Final Subsequent Environmental Impact Report

# Sunshine Canyon Landfill

State Clearinghouse Number 92041053

**October 1998**

| FIGURE NO.  | 2.7-3a (REVISED) |

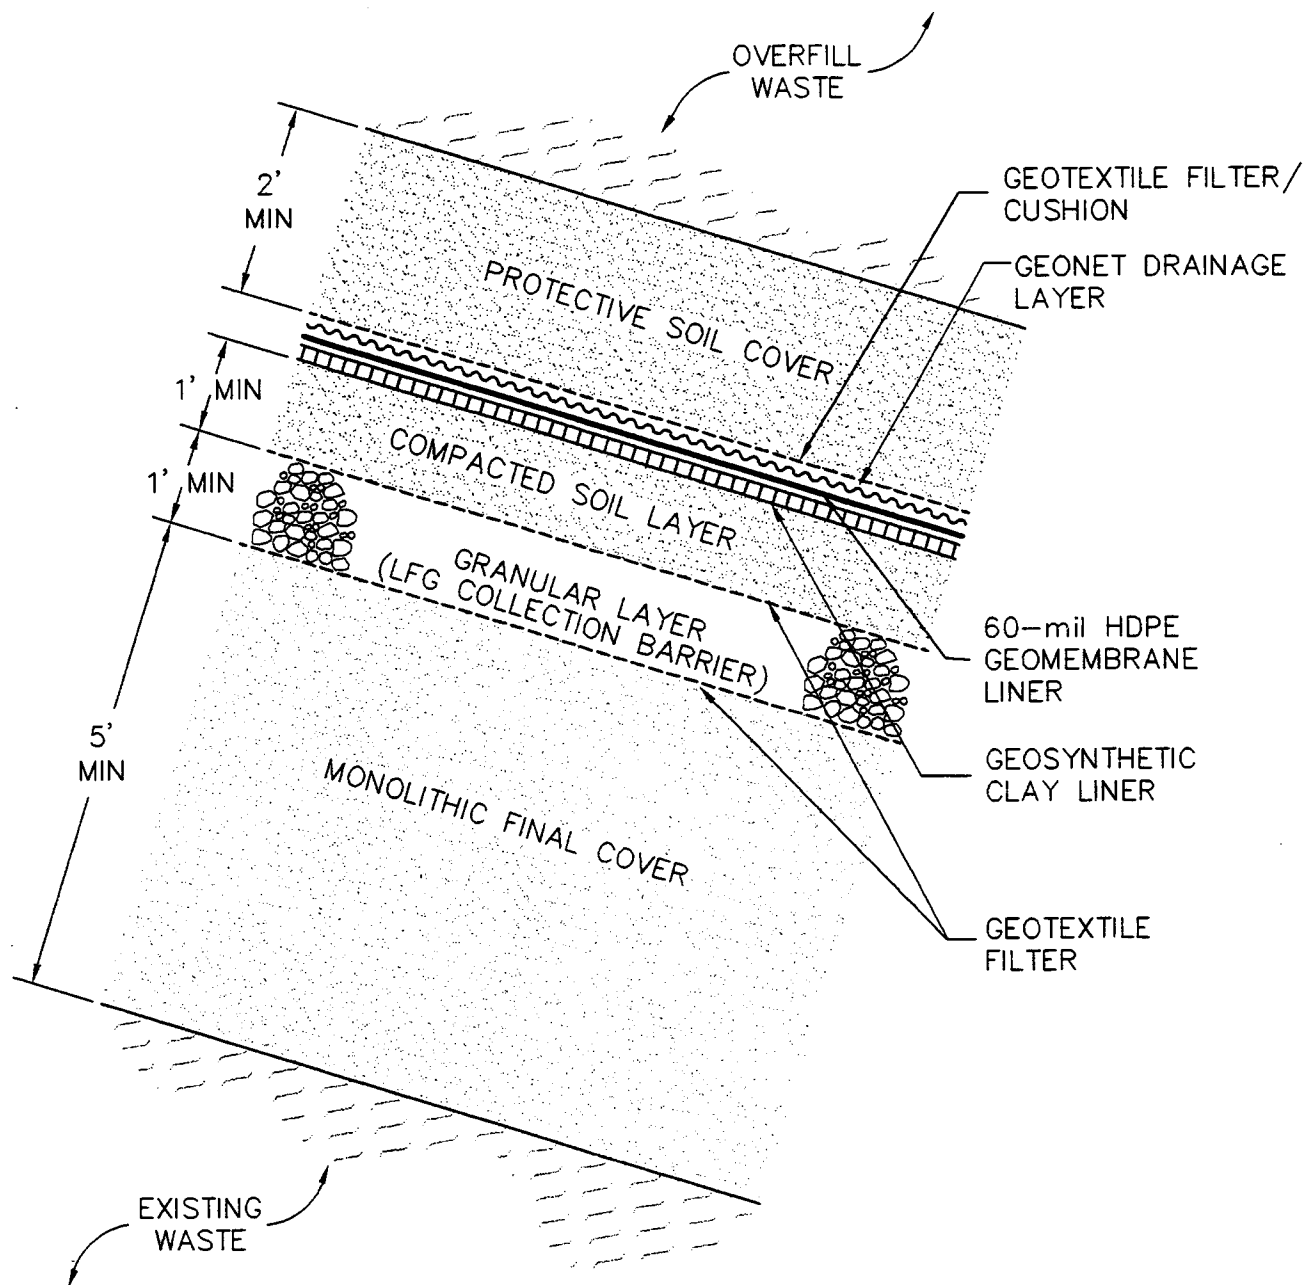
#### Section 2.7.4, Leachate Collection and Removal System, Figure 2.7-3, p. 2-59

Figure 2.7-3 (Preferred Waste-on-Waste Liner) has been revised as Figures 2.7-3a (Monolithic Cover for Sunshine Canyon City Landfill Closure) and 2.7-3b (Preferred Waste-on-Waste Liner and Re-compacted Monolithic Final Cover) to reflect the proposed monolithic final cover and the waste-on-waste liner.

**FIGURE 2.4-5**  
(Revised)

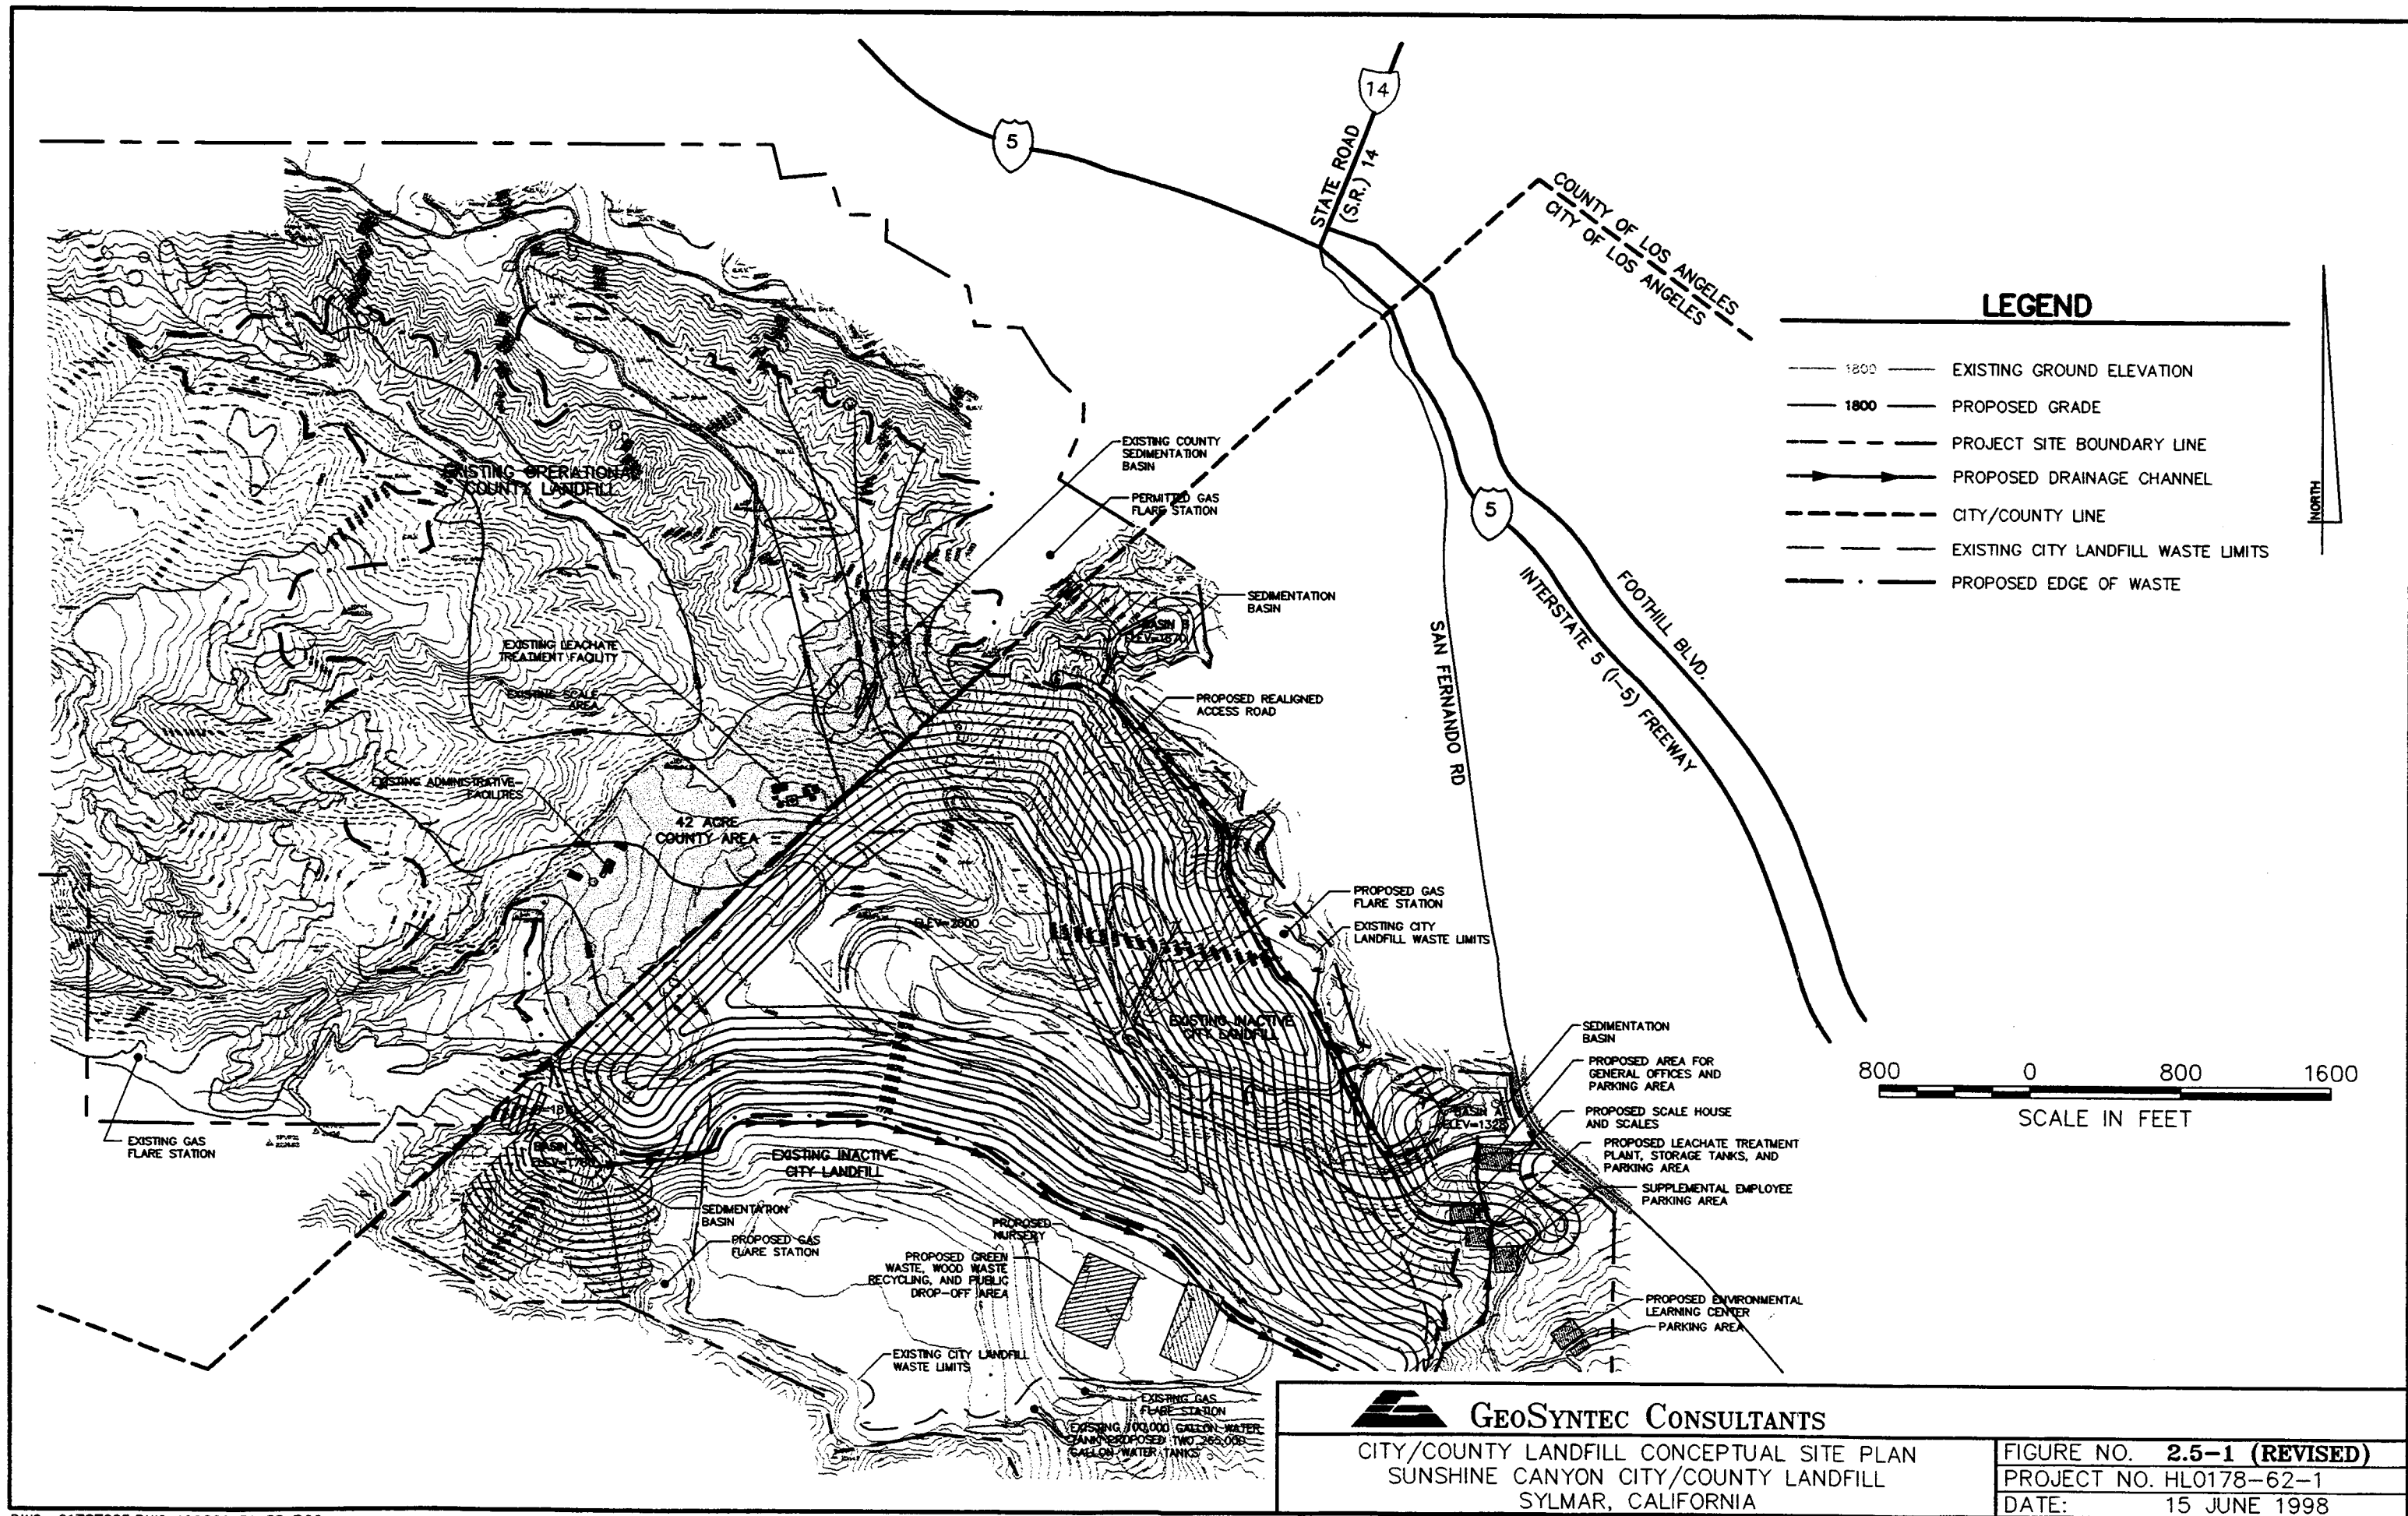
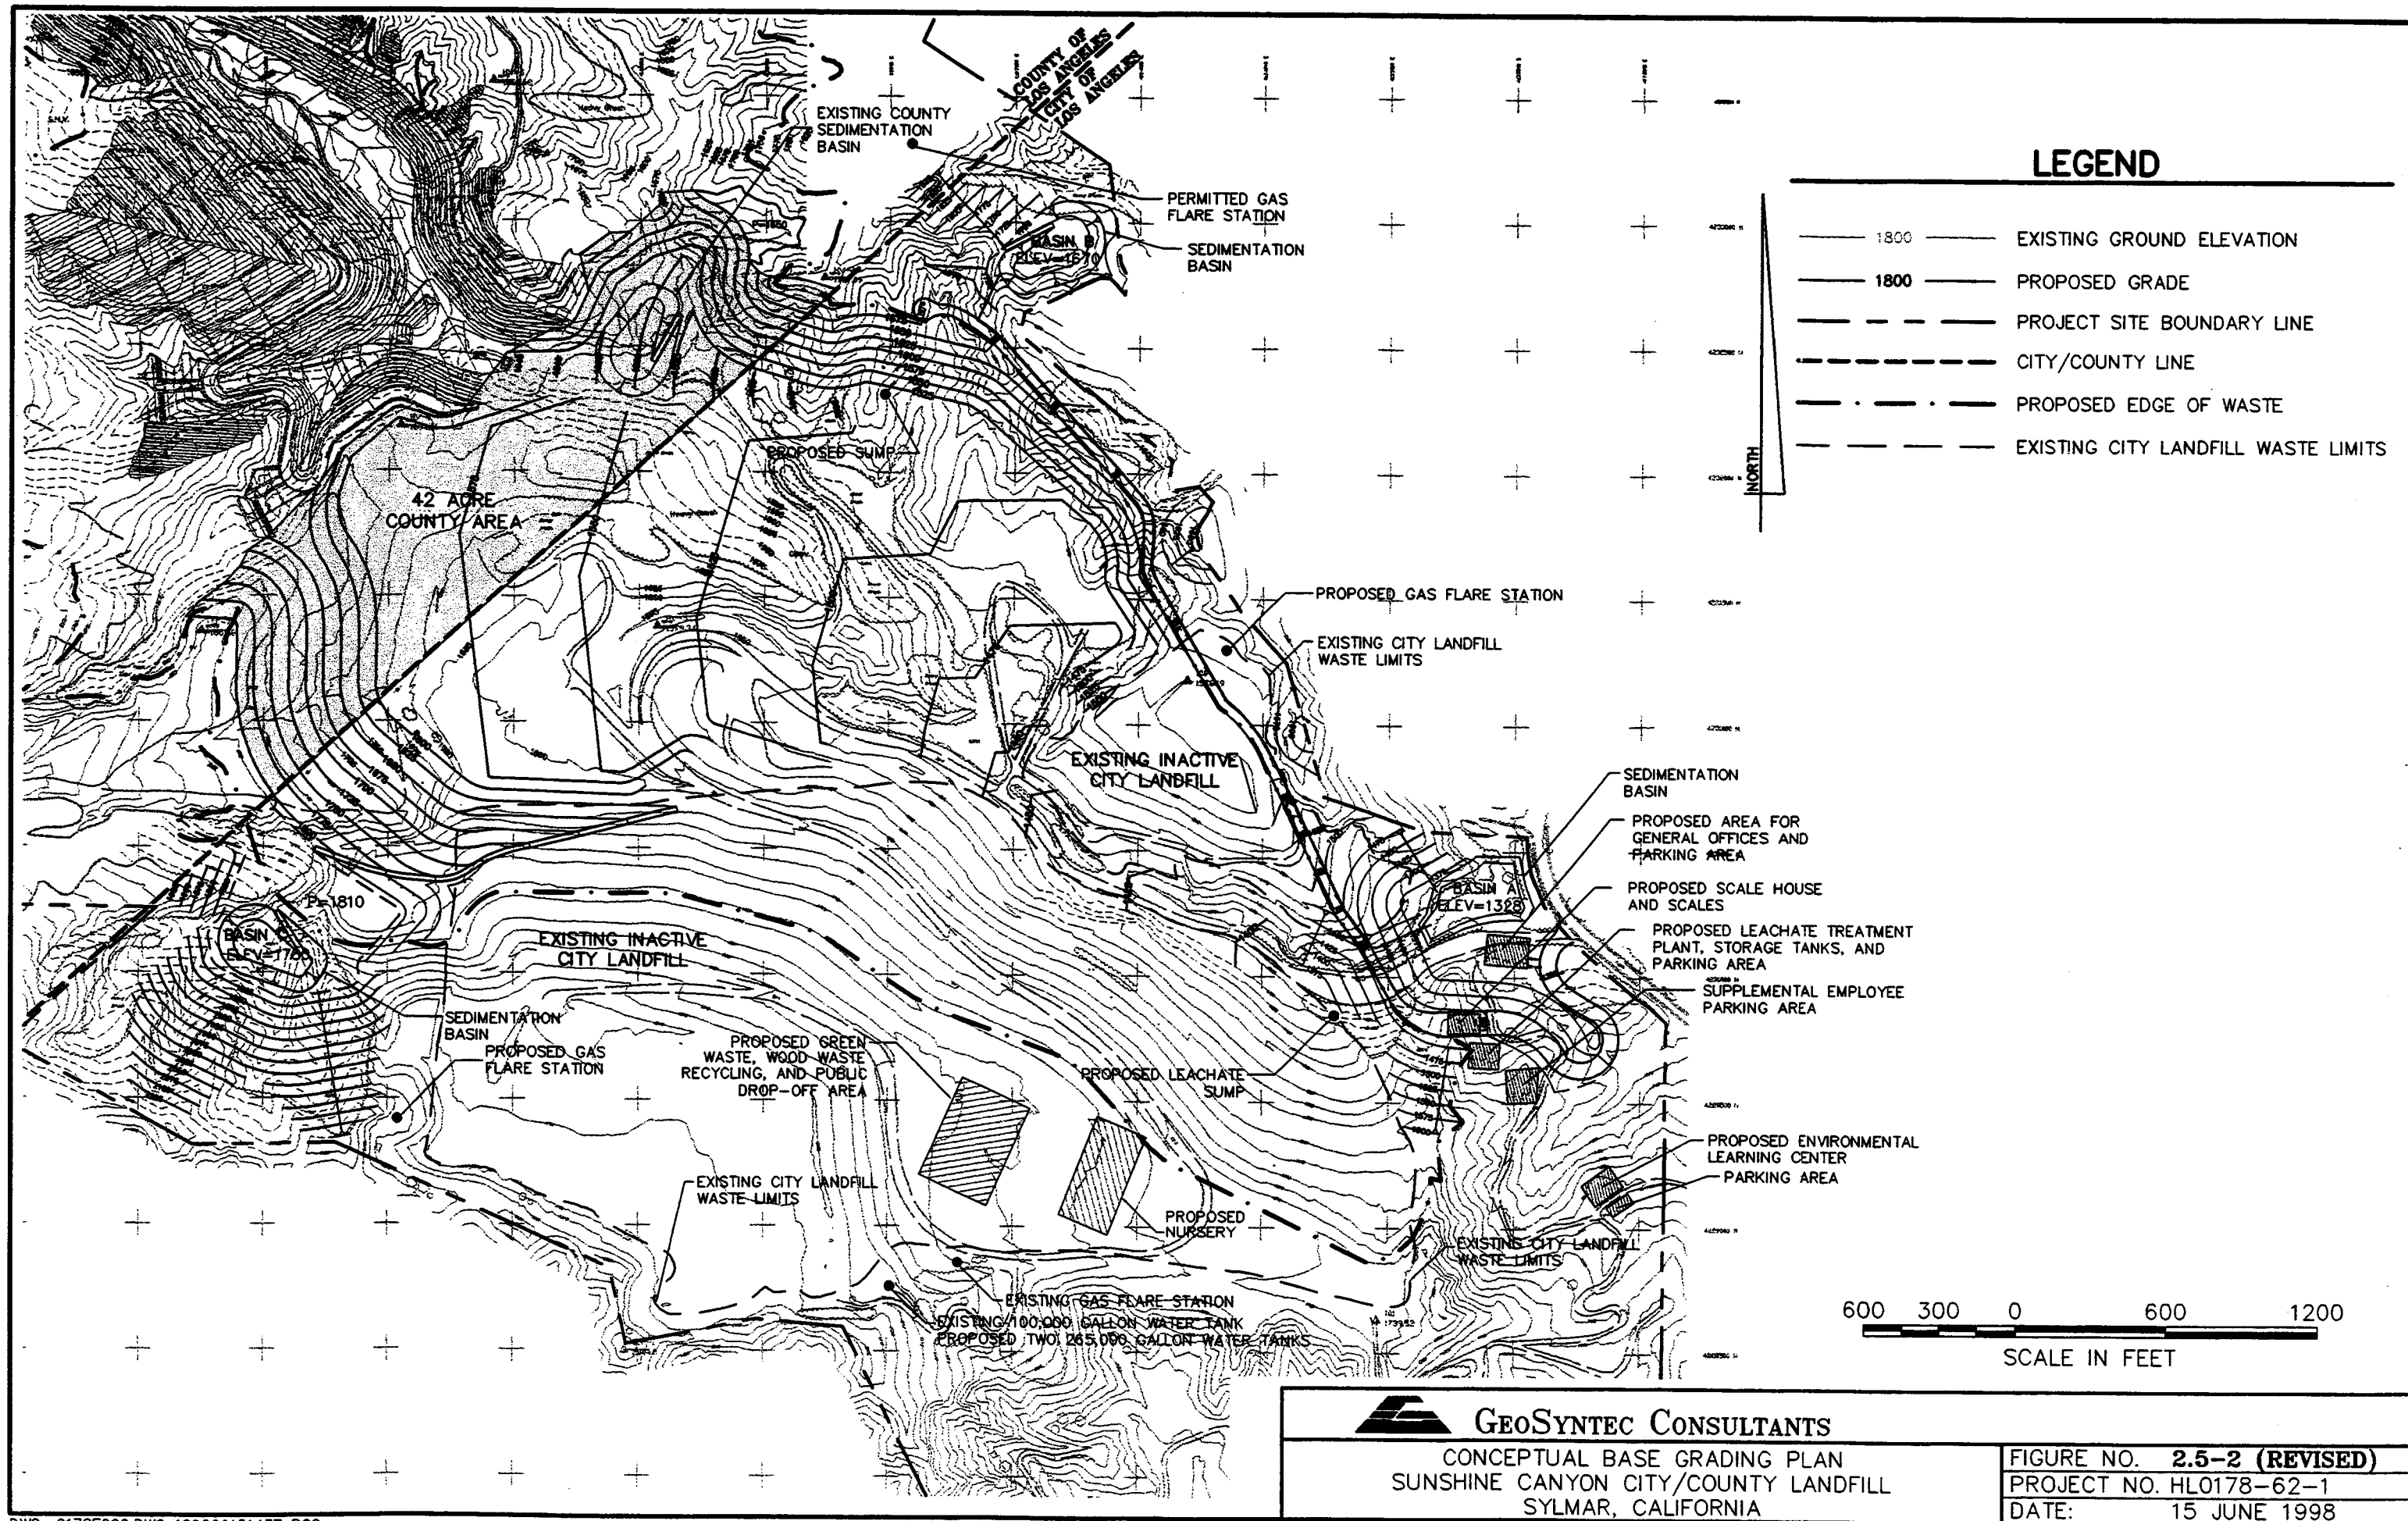
Section 2.4.4, Surrounding Land Uses, Figure 2.4-5, p. 2-19

Revisions to this figure, made by the project proponent, are not in response to any of the comments included in Section 3.0 of this document.
